Landform 1 with RDI shift suggestion

Analysis of FL 19232 Visual Quality

Dr. Ken Fairhurst, RPF, RDI Resource Design Inc, was asked by Interfor Corporation to review the Visual Plan prepared for the proposed FL A19232 cutblocks 129 and 227. RDI has 20 years of progressive experience in all aspects of Visual Resource Management and Planning in all regions of British Columbia, and is highly-regarded as an independent advocate for excellence in the professional discipline of VRM.

Visual Impact Assessment
Bear Lake – FL A19232

Interfor Current Plan from Viewpoint 3 with RDI suggested merge and shift for Landform 1

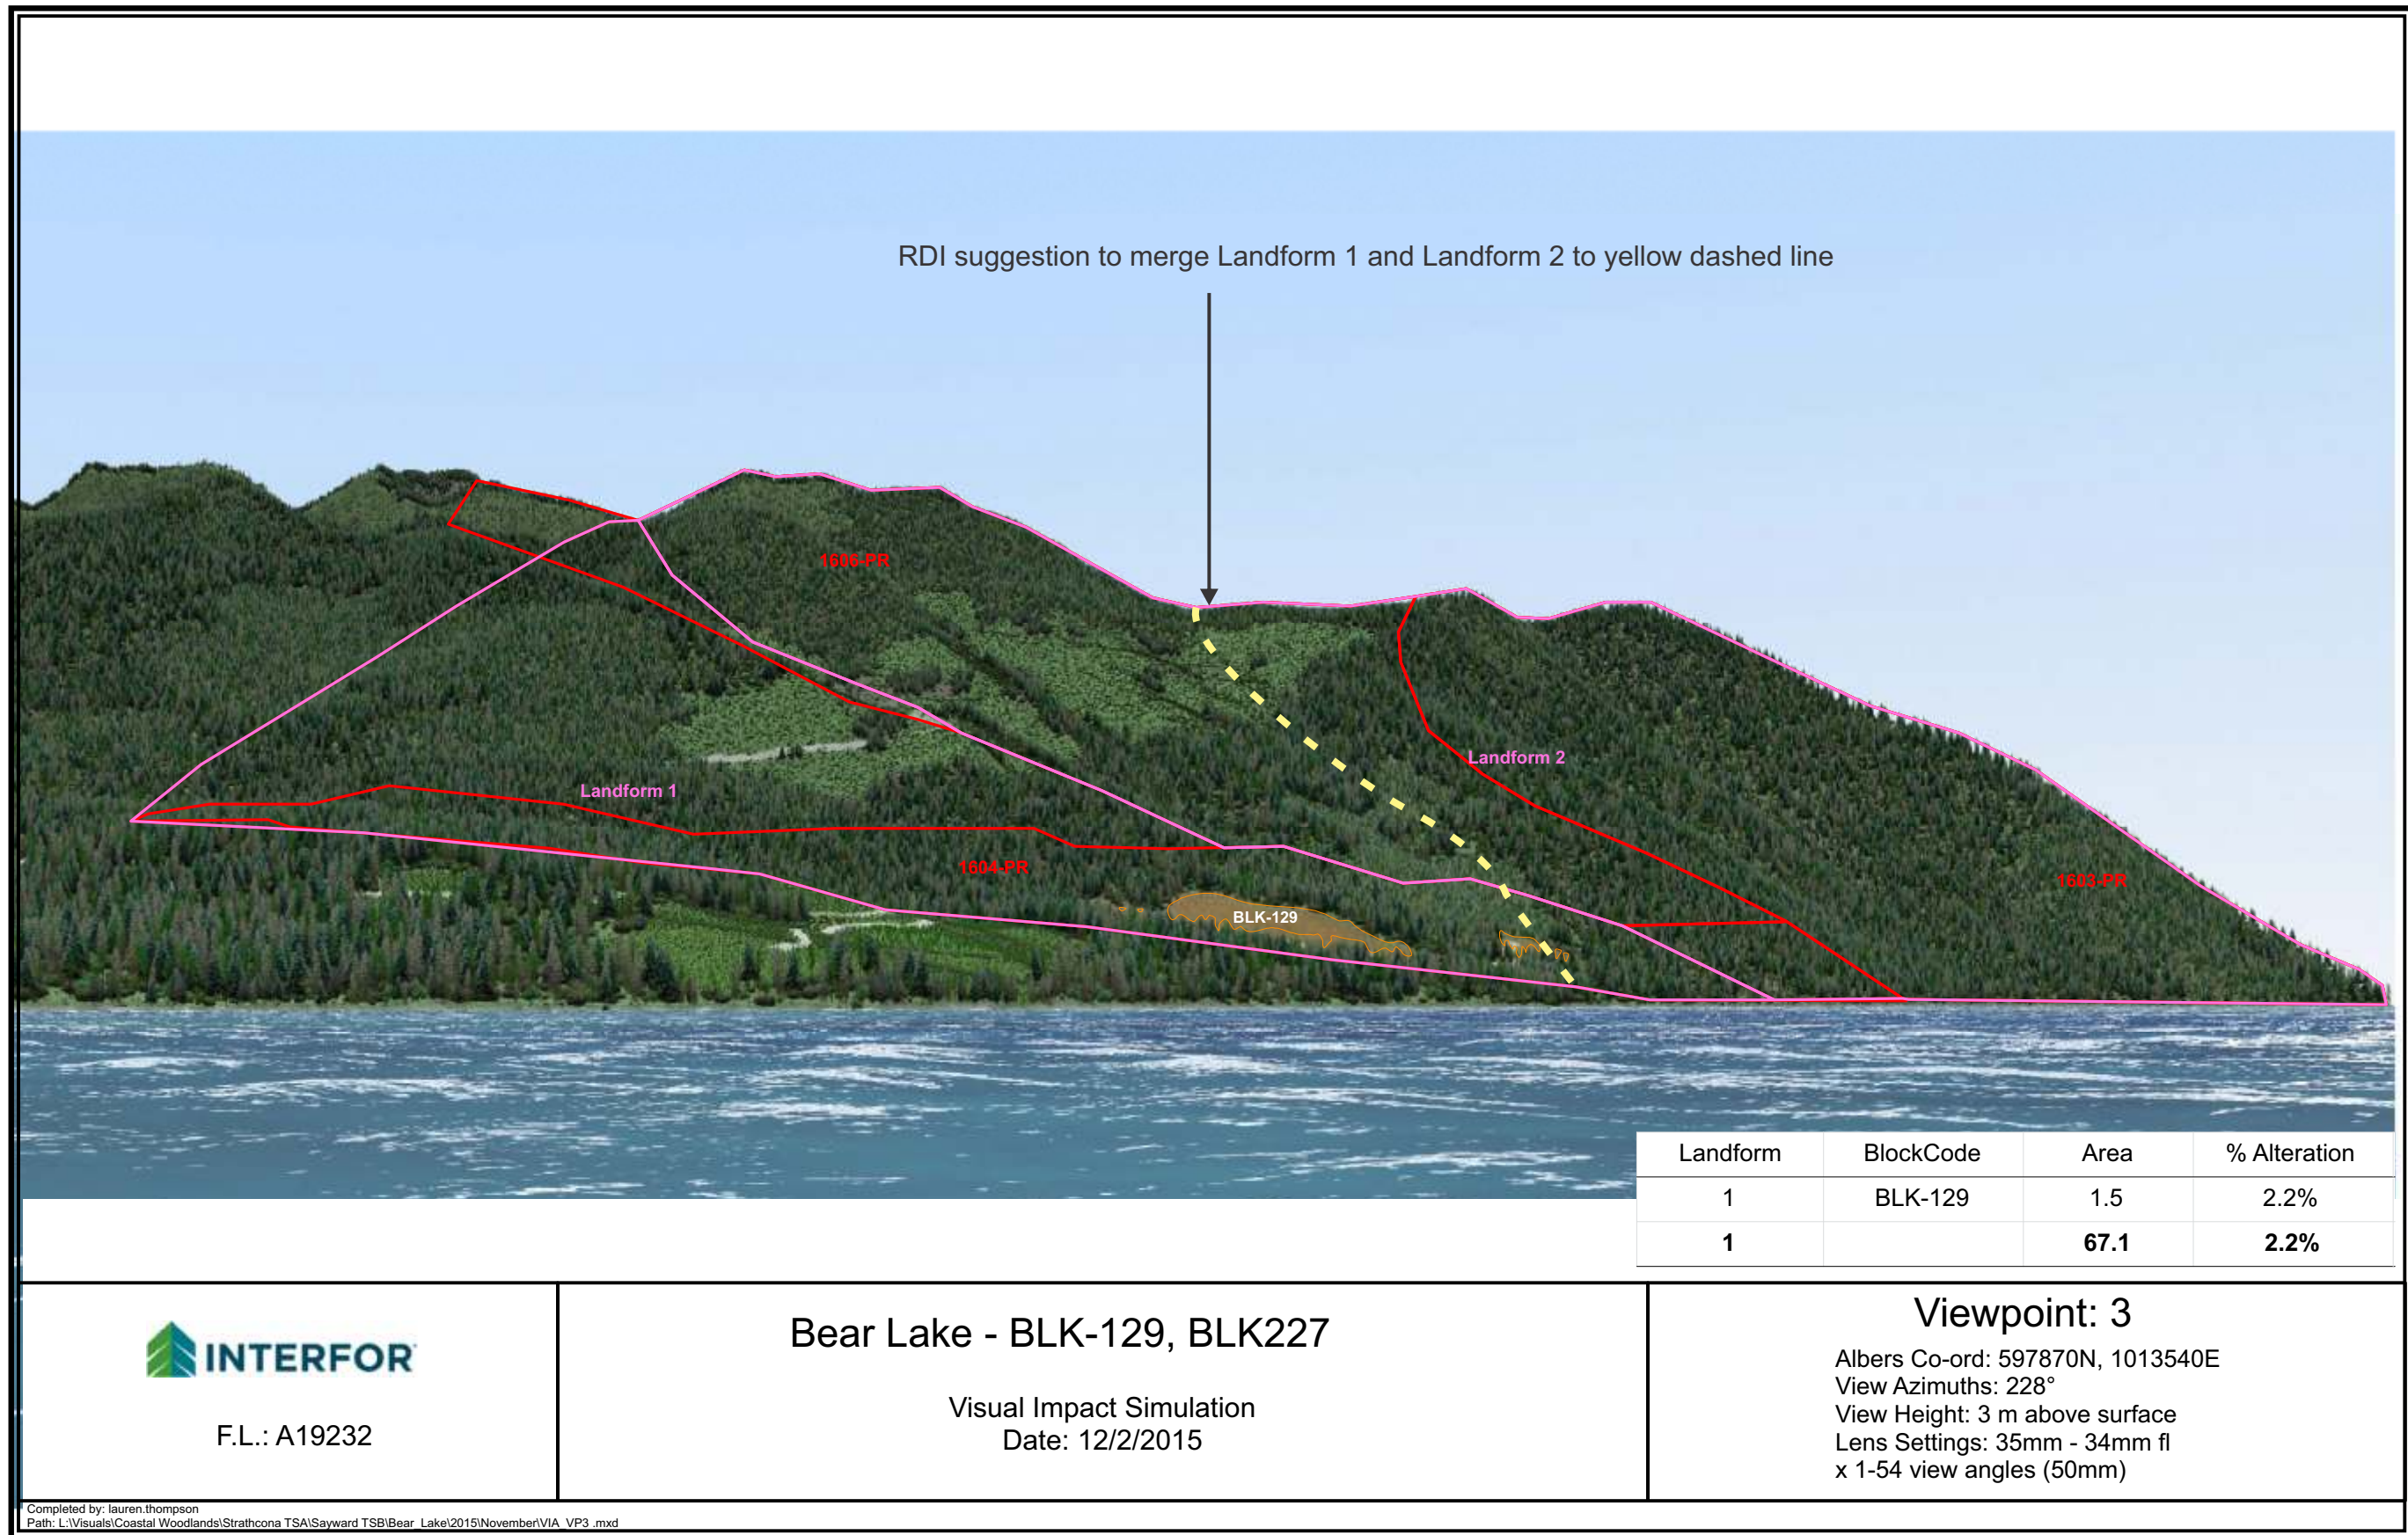
The Landform 1 identified in the Viewpoint 3 simulation is similar to the Landform 1 indicated in the Viewpoint 2 simulation, except that it includes all of the visible development of cutblock 129. Block 227 is not visible from this viewpoint, as it will be screened from view by the VSU 138 landform. RDI suggests that this version of Landform 1 be expanded to between LOF G1 and LOF G7 for consistency with the other viewpoint versions. Placement of landform boundaries on the key map and LOF on the viewpoint image by Interfor would assist that understanding.

Interfor Photo VP 3 with Interfor Landform 1 and 2 and RDI suggested landform merge and shift

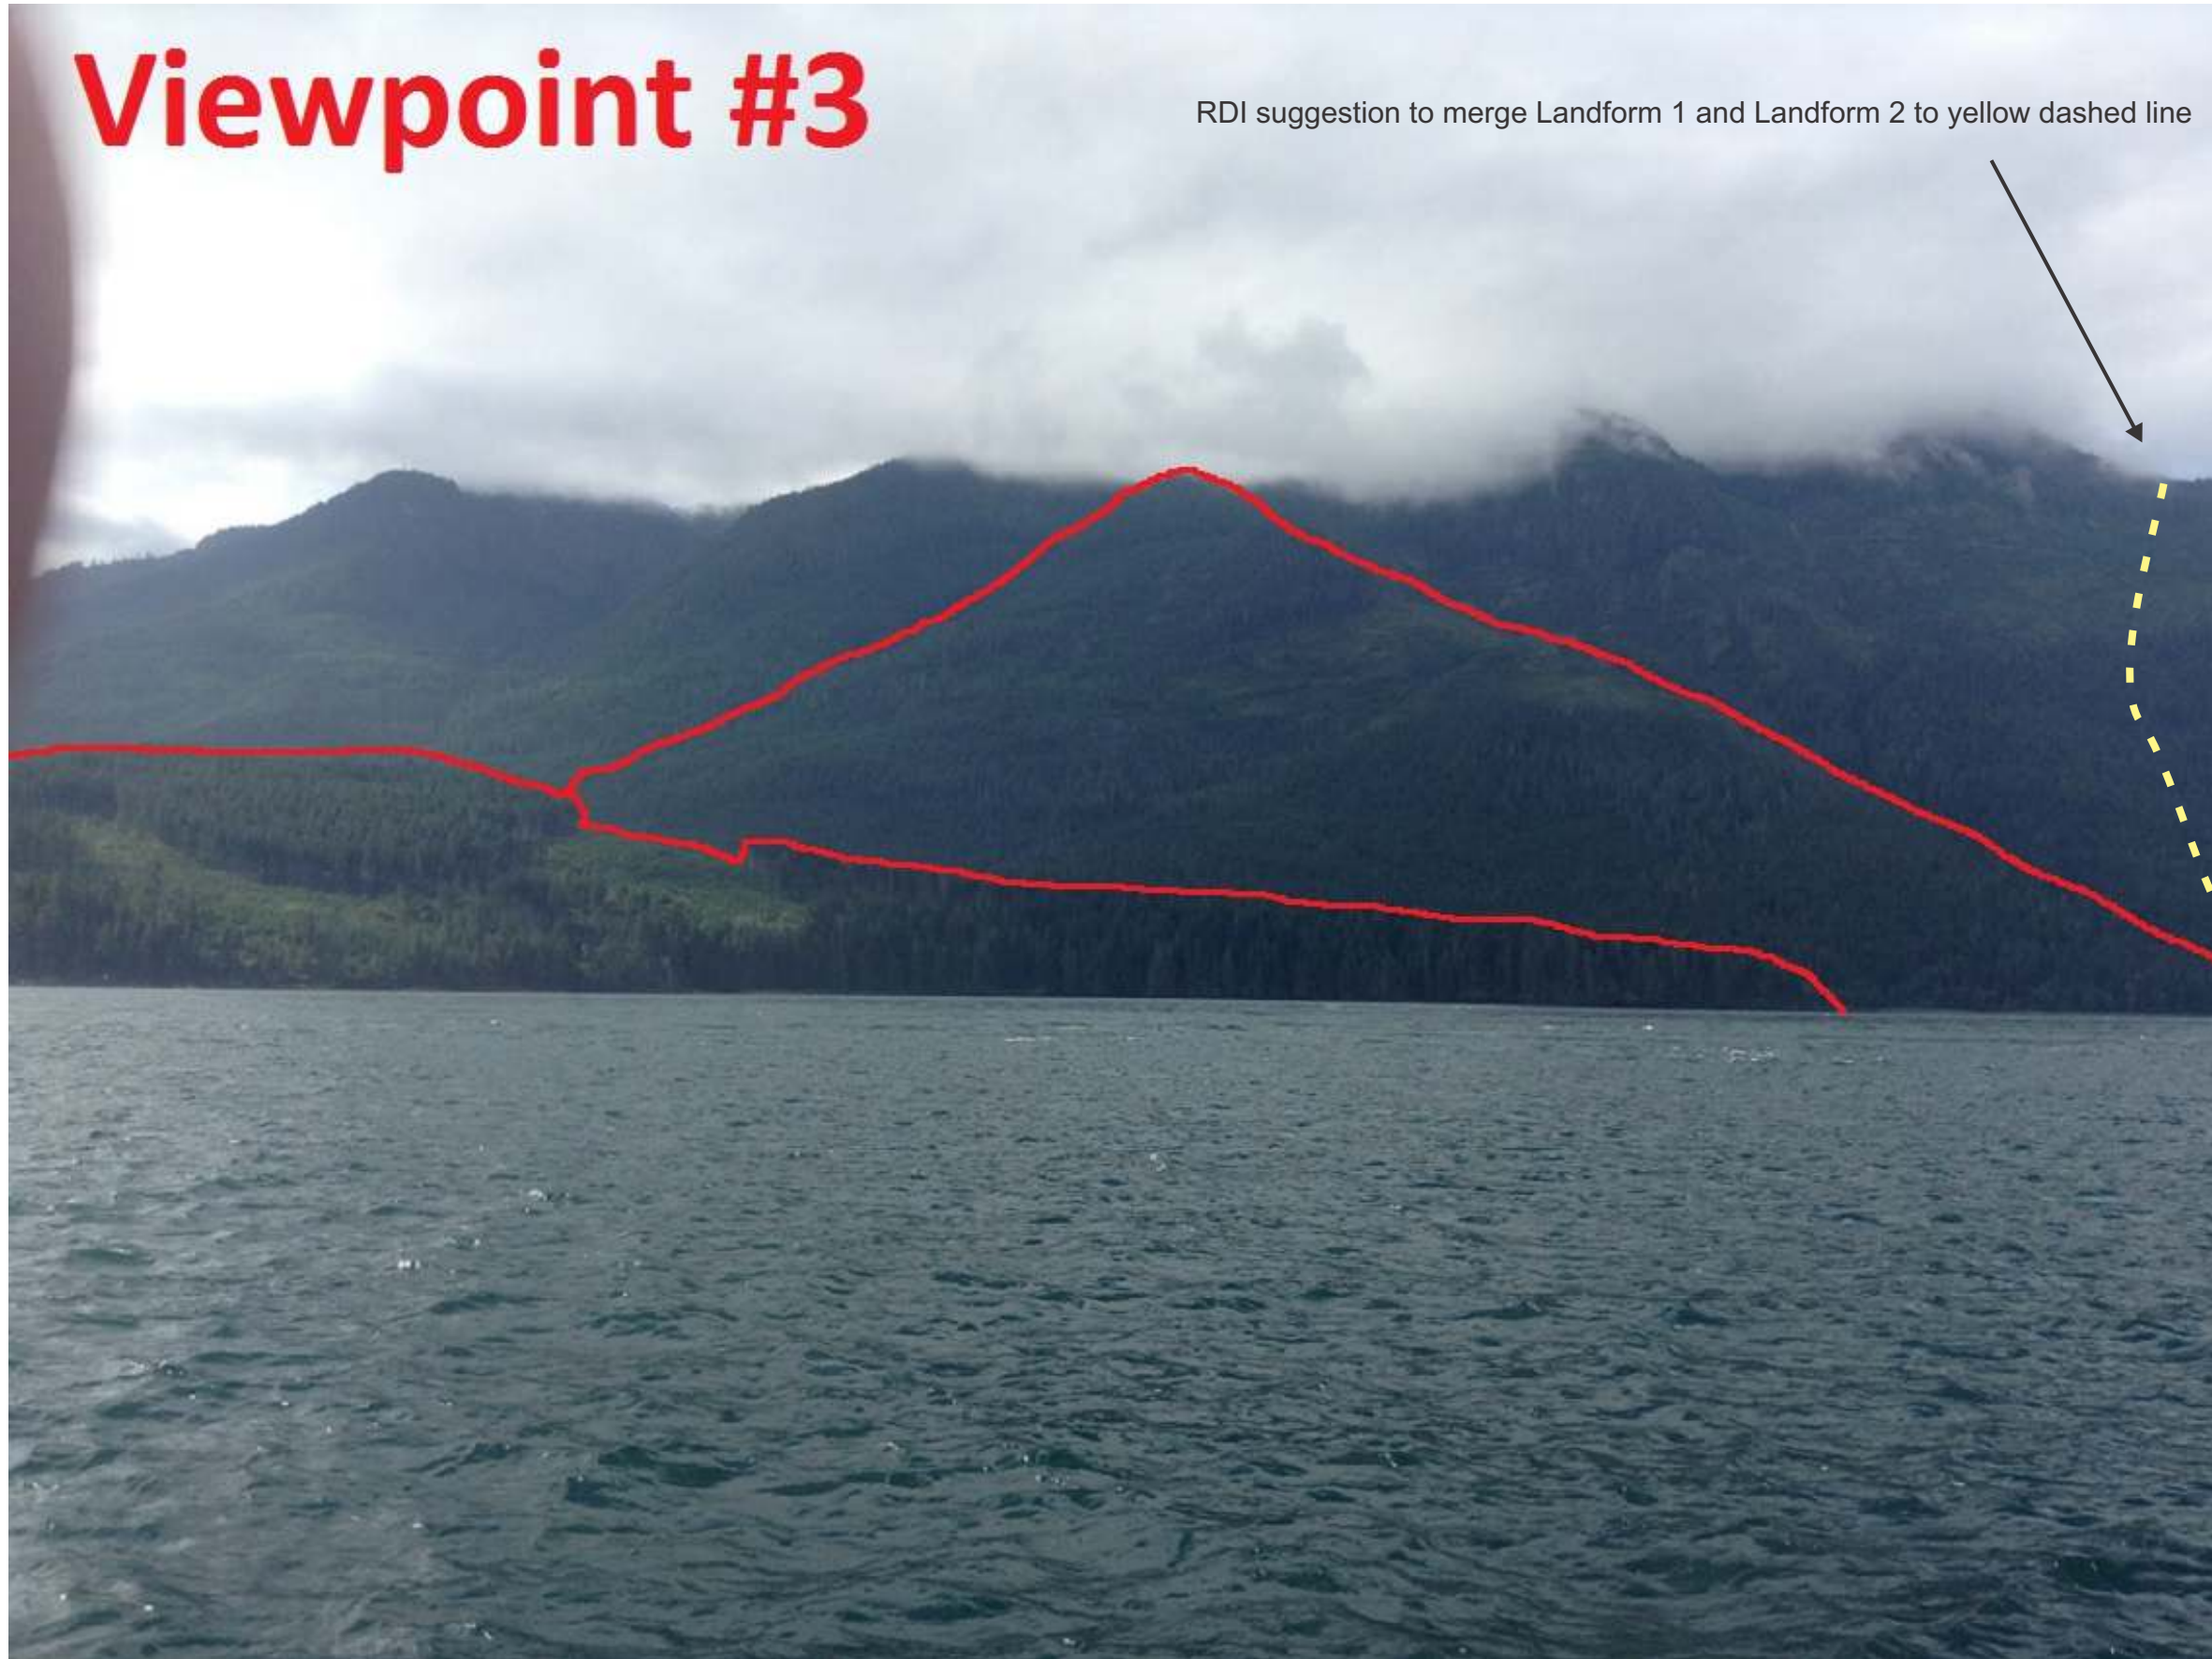
RDI suggestion to merge Landform 1 and Landform 2 to yellow dashed line
